**From:** [Christina Beck](#)  
**To:** [Kelly Bacon \(CD\)](#)  
**Cc:** [sanjay@shreeinvestmentsinc.com](mailto:sanjay@shreeinvestmentsinc.com); [Ekta Saini](#); [Shahrose Saini](#); [Joe Park](#)  
**Subject:** Shree Thorp Convenience Store Addition, SEPA Application SE-21-00024  
**Date:** Thursday, December 16, 2021 11:04:39 AM  
**Attachments:** [20211216.pdf](#)  
[Storm Water Plan - Thorp.PDF](#)  
[Subway Drawings.pdf](#)

Re: Shree Thorp Convivence Store Addition, SEPA Application (SE-21-00024)

Please see below for responses to the comments received from the SEPA Application for the Thorp Addition.

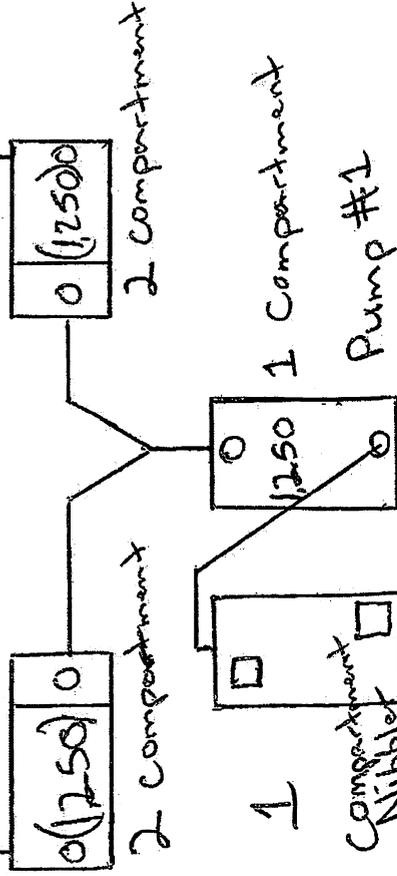
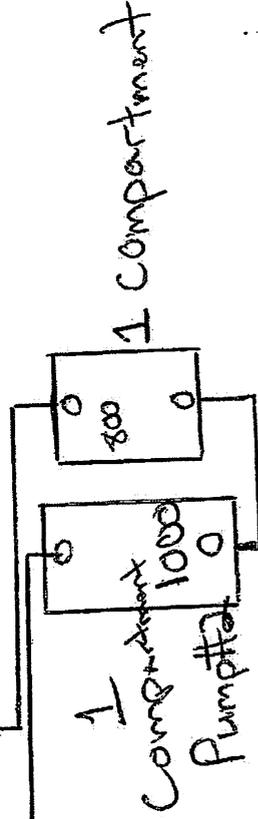
- Concerns with peak daily wastewater flows were expressed, and if they are more than 3,500 gallons per day. We have reached out to Mark Nelson with MCN Consulting. We are awaiting a response from him for a time to schedule this. I have attached the most recent inspection for review from 2019 that shows the capacity of the tank, and that is it is in good working order.

- Regarding the new septic GPD, we have reached out to Mark Nelson with MCN Consulting. We are awaiting a response from him for a time to schedule this. I have attached the most recent inspection for review from 2019 that shows the capacity of the tank, and that it is in good working order.

System appears to be working properly as of 12/23/19. See attached image for layout of system.
